752 MARINE DRIVE

REVISED DESIGN CONCEPT

The following is a response to the comments provided by the Design Review Committee on November 20th, 2014. It addresses the following issues:

HEIGHT AND RELATIONSHIP TO MARINE DRIVE

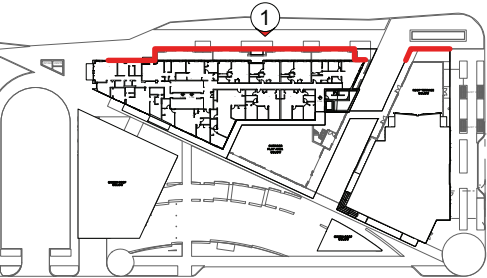
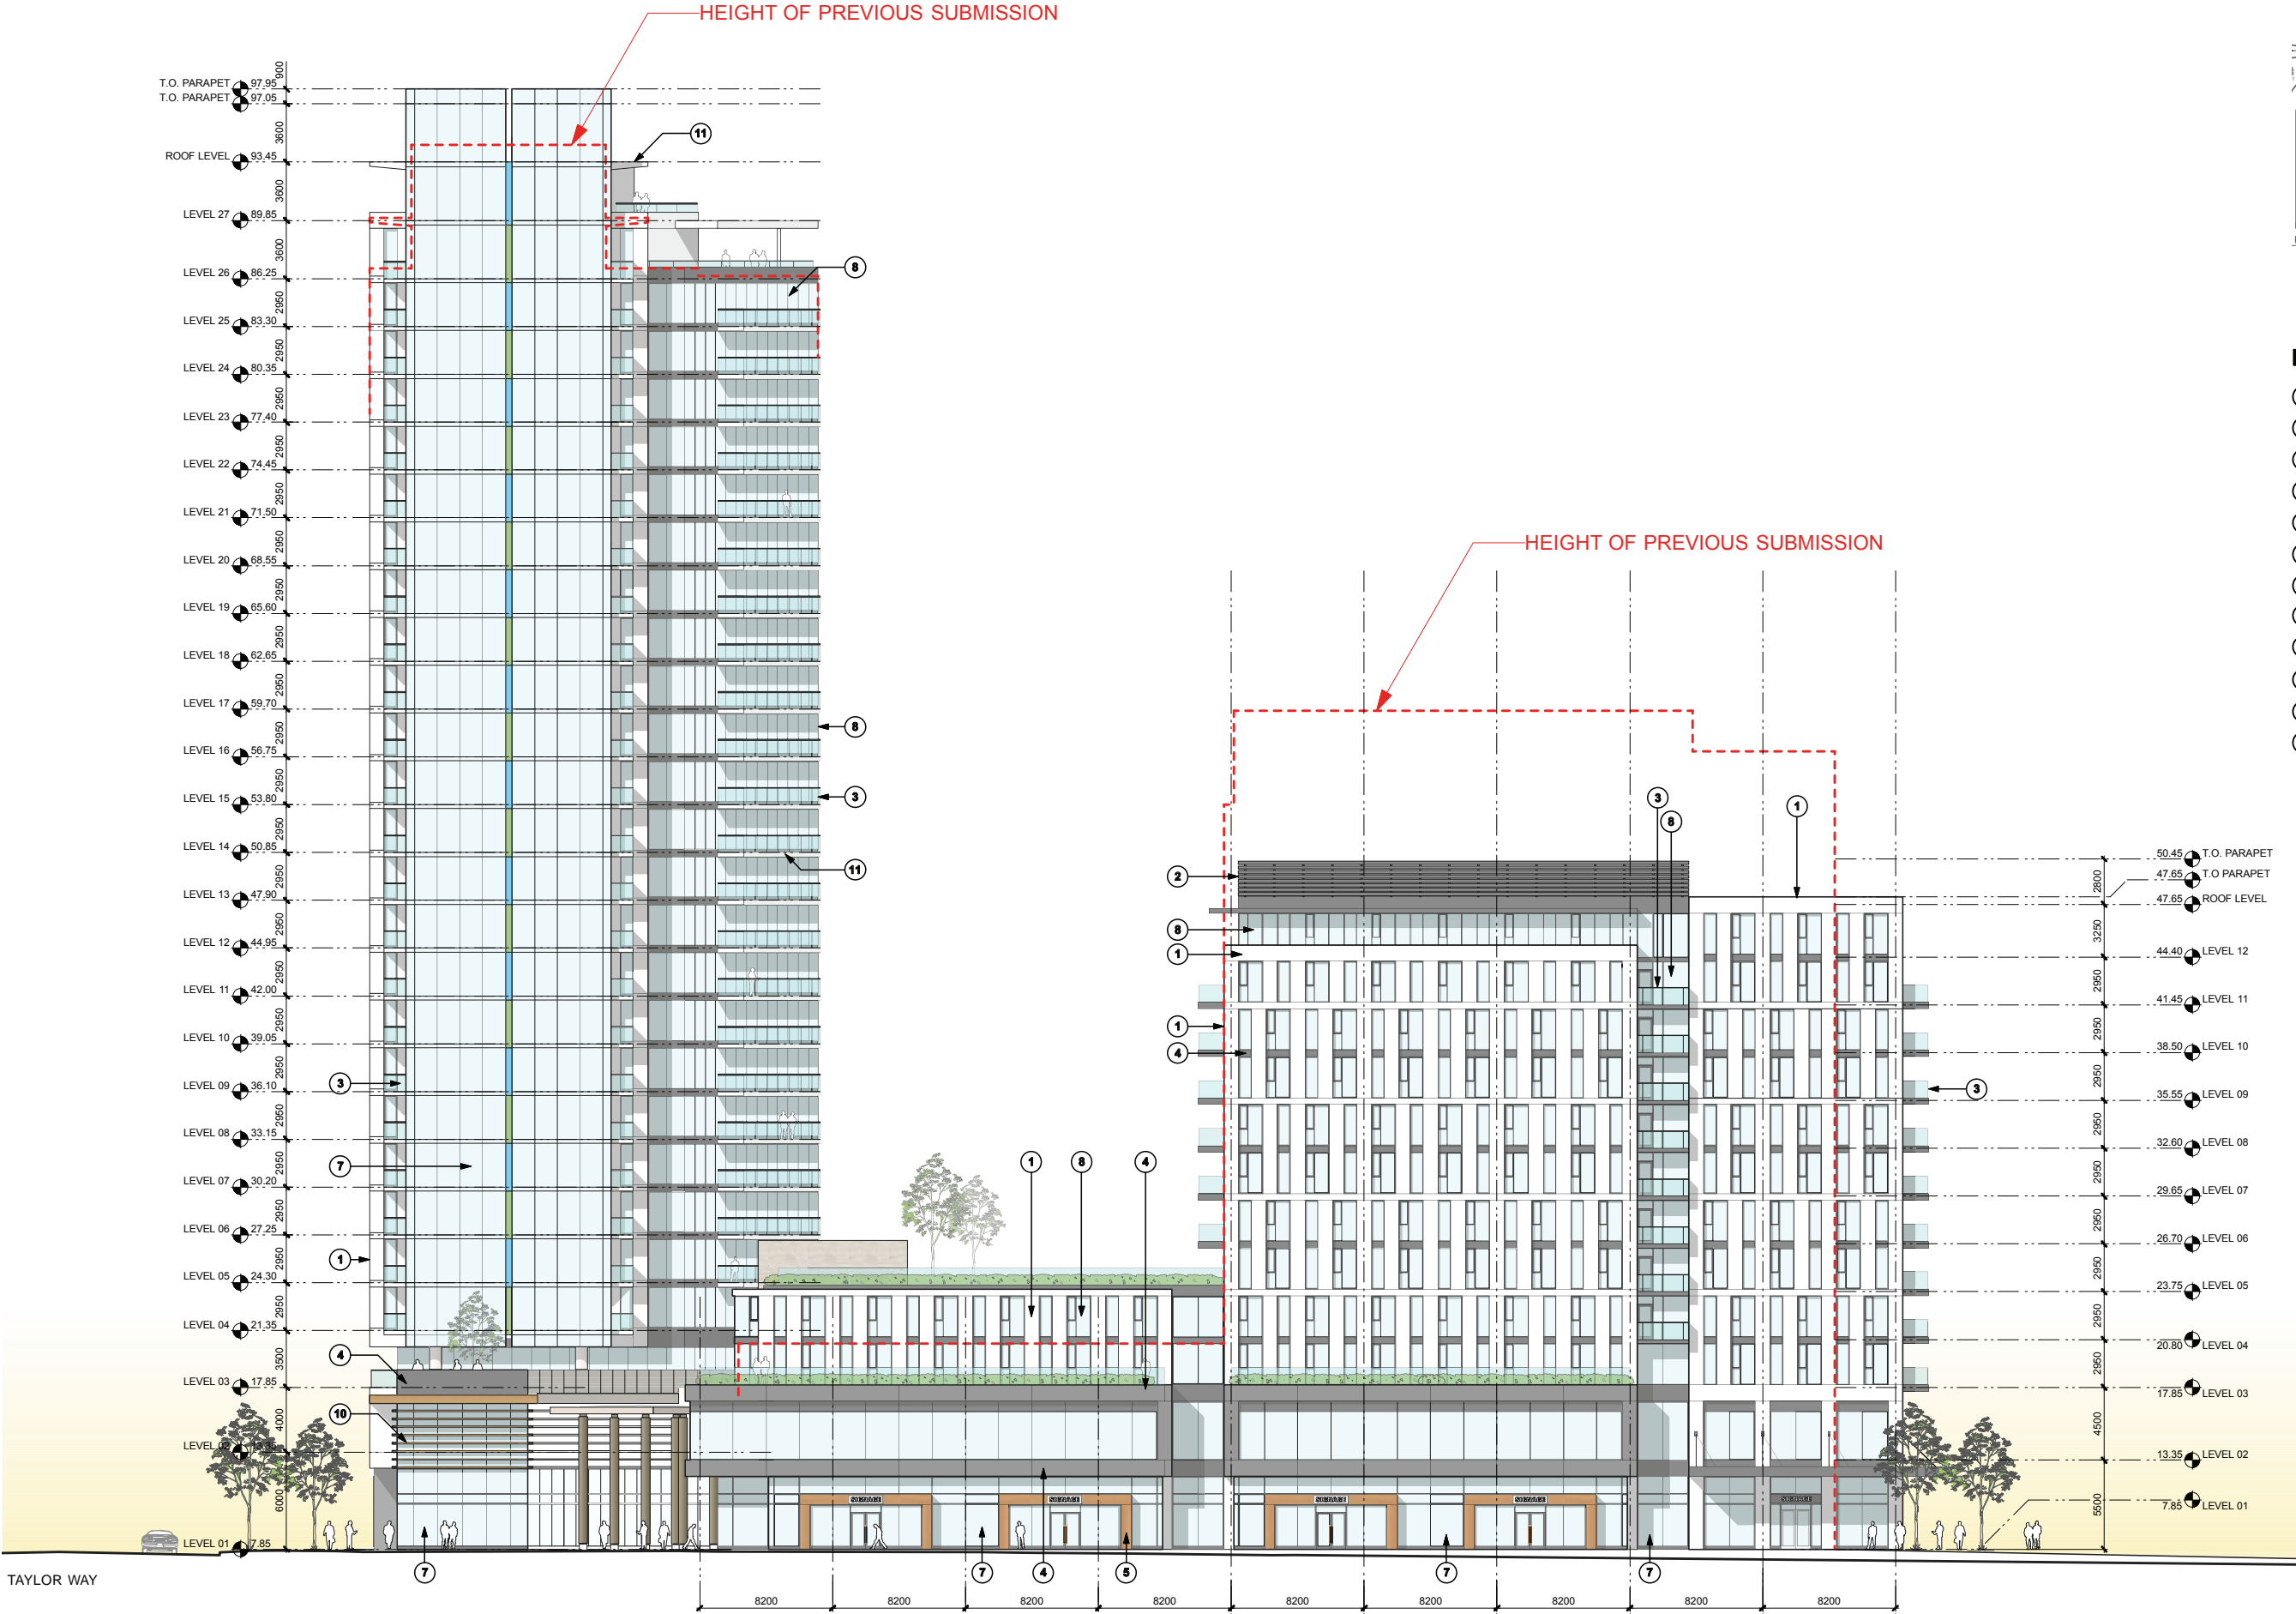
HEIGHT OF WEST TOWER REDUCED BY 3 STOREYS

To off-set the loss of density caused by this reduction in height, the west tower (now 12 storeys) has been extended further to the west and another level has been added to both the podium (now 4 storeys) and the east tower (now 27 storeys)

EAST TOWER CURTAIN WALL

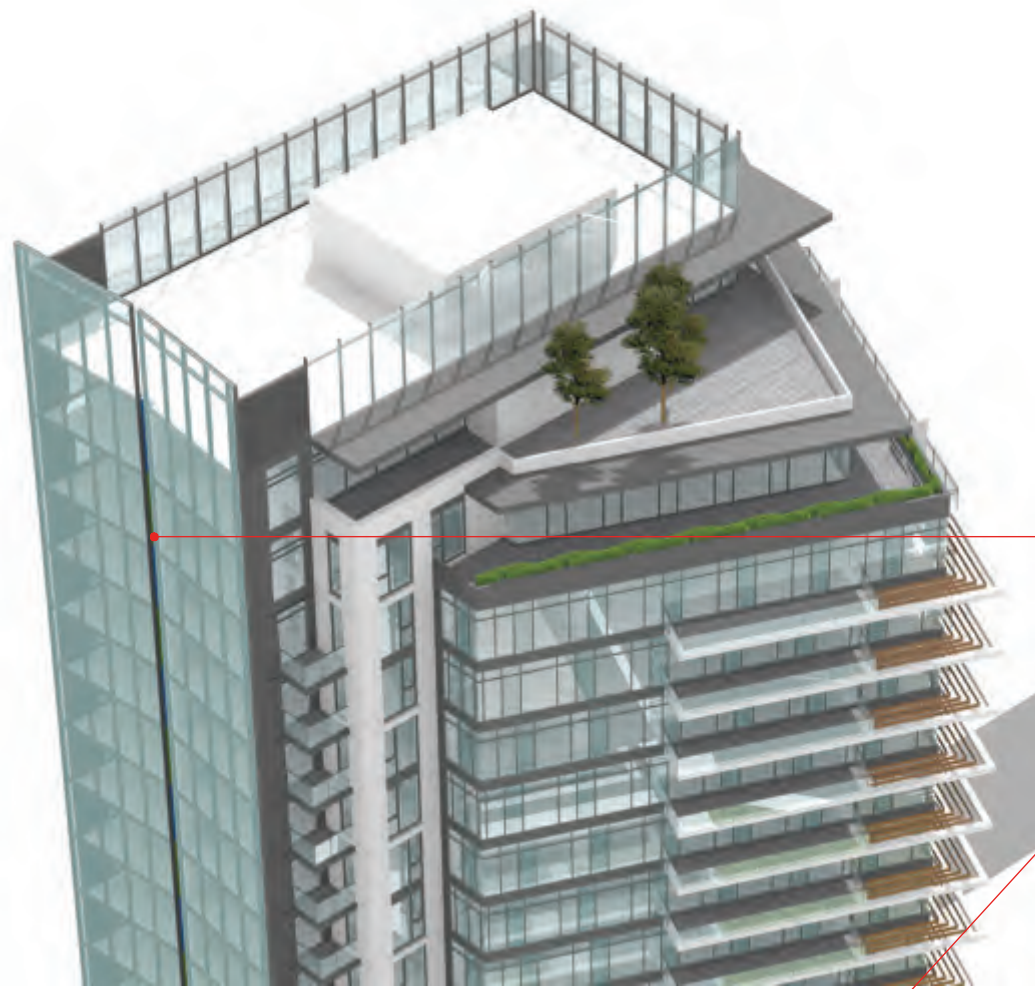
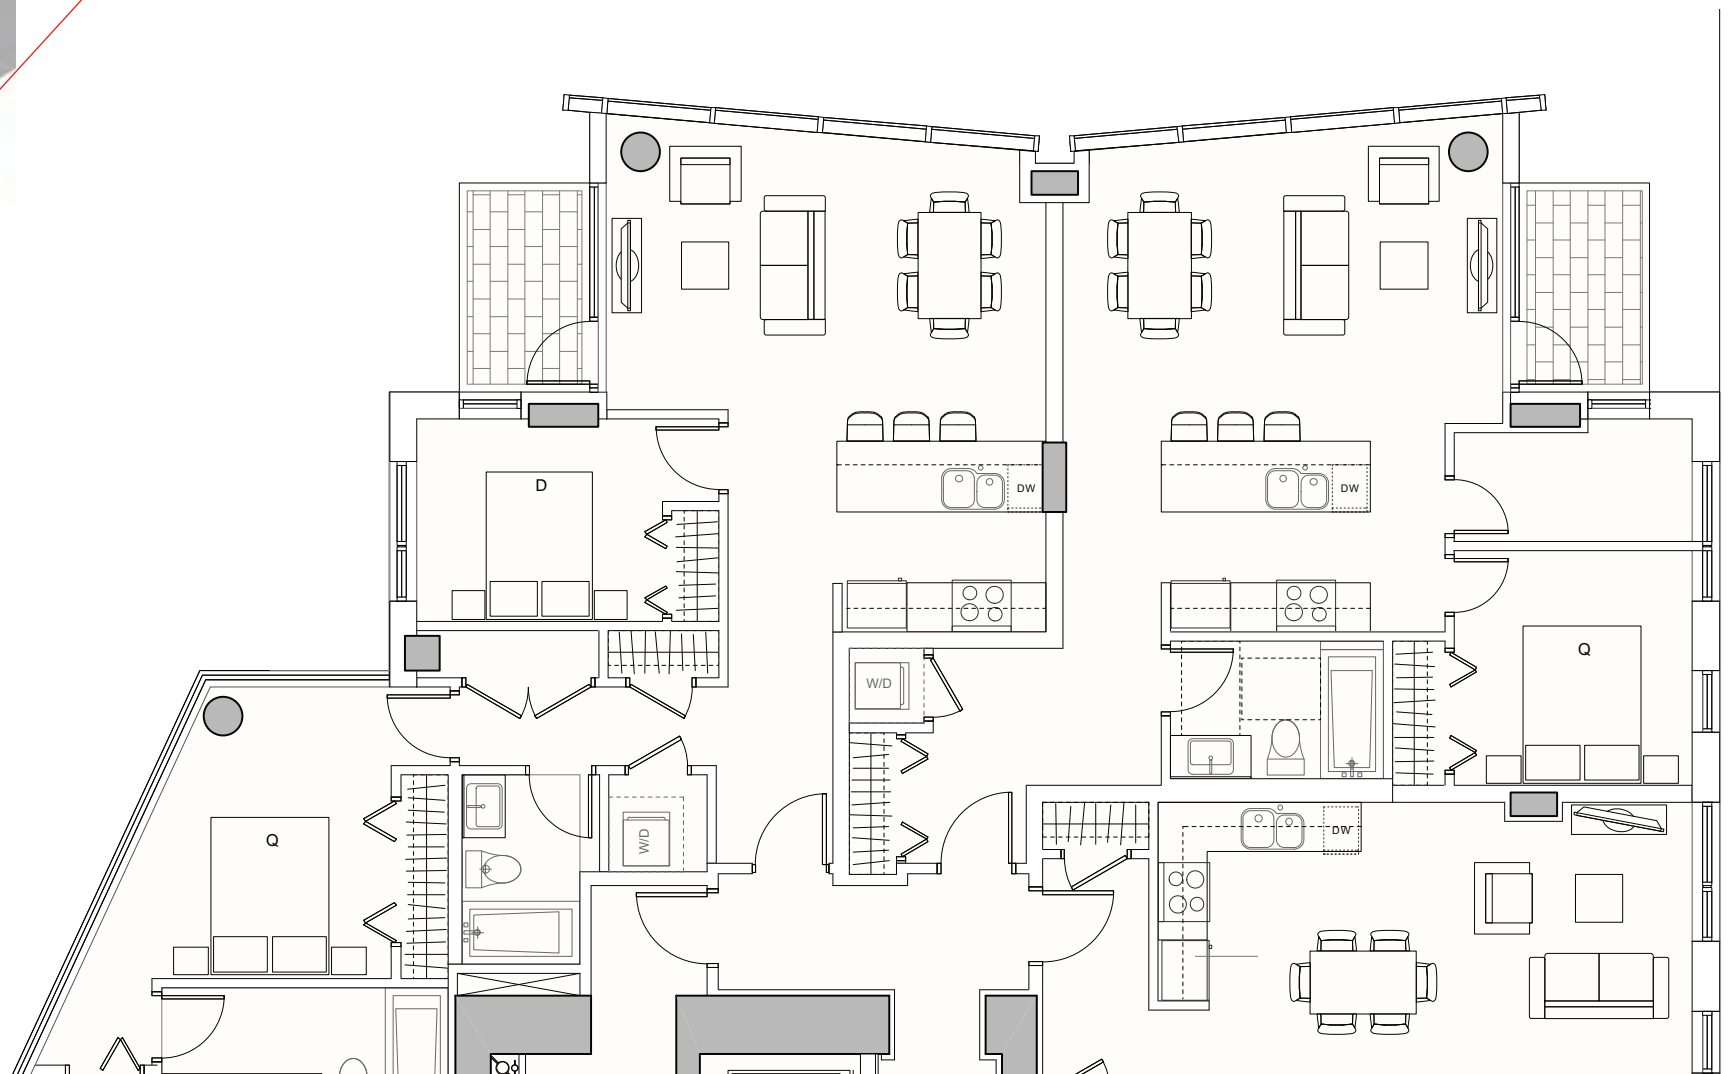
THE NORTH CURTAINWALL HAS BEEN MODIFIED TO PROVIDE GREATER VISUAL INTEREST. PLANES OF GLASS HAVE BEEN ANGLED AND A REVEAL HAS BEEN CREATED DOWN THE MIDDLE. THIS REVEAL WILL HAVE ALTERNATING COLOURED PANELS AND COULD POTENTIALLY BE ILLUMINATED AT NIGHT.

RETAIL GALLERIA

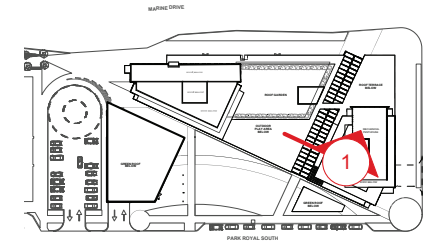
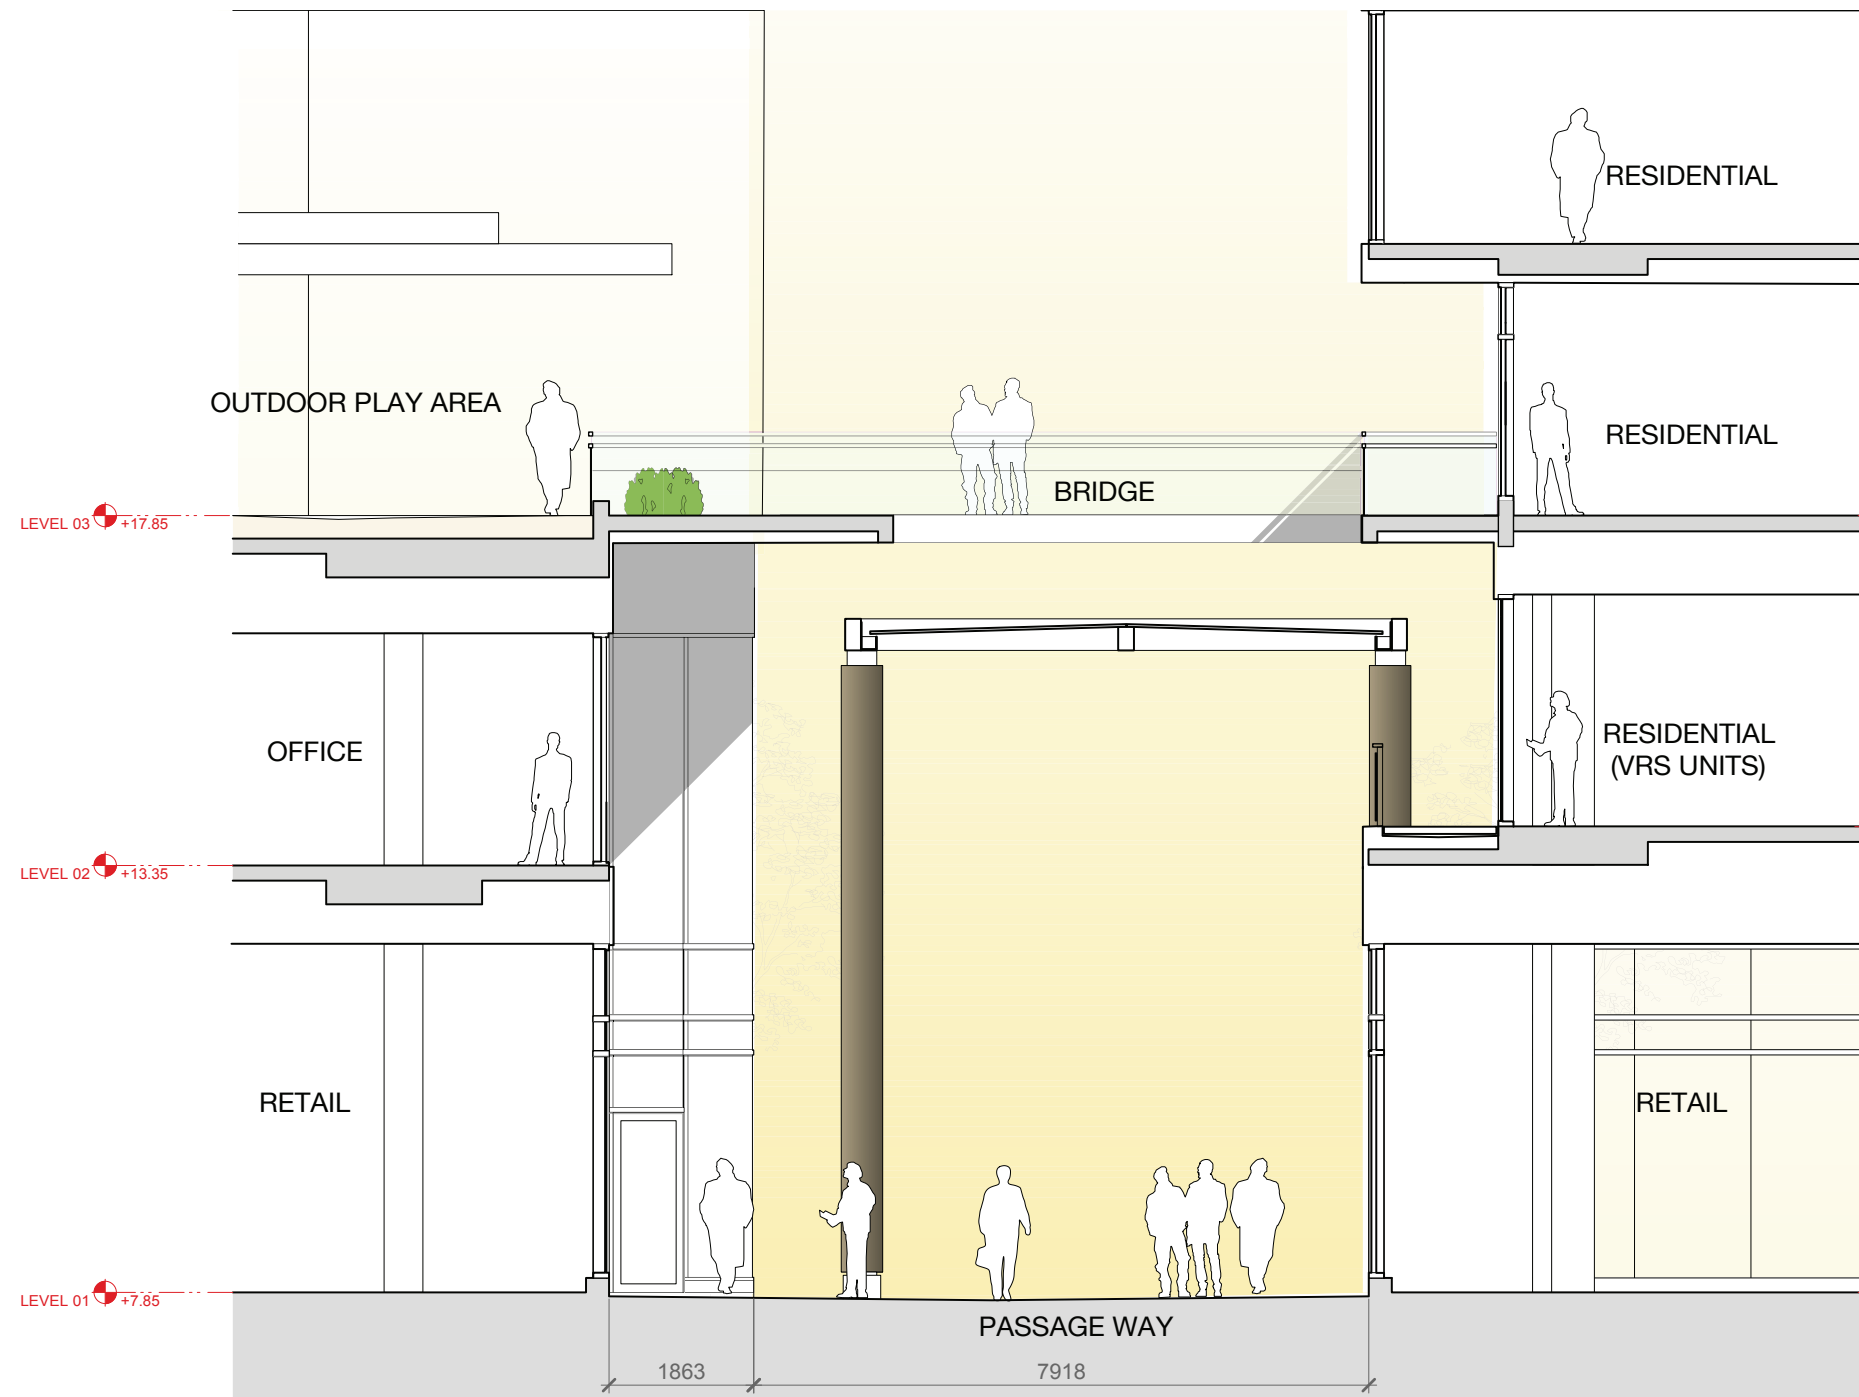
GREATER TRANSPARENCY IN OFFICE PODIUM

GREATER TRANSPARENCY AT CORNER RETAIL UNIT

NEW WATER FEATURE TO MARK THE ENTRANCE TO PARK ROYAL

- GLAZED CANOPY TO PROVIDE WEATHER PROTECTION
- BANNERS TO PROVIDE GREATER ANIMATION
- ENTRANCE TO OFFICE LOBBY MORE CLEARLY INDICATED
- OVERHEAD DOORS ALLOW ACTIVITY TO SPILL OUT INTO GALLERIA
- ADDITIONAL ENTRIES PROVIDED ALONG RETAIL GALLERIA FOR GREATER ANIMATION
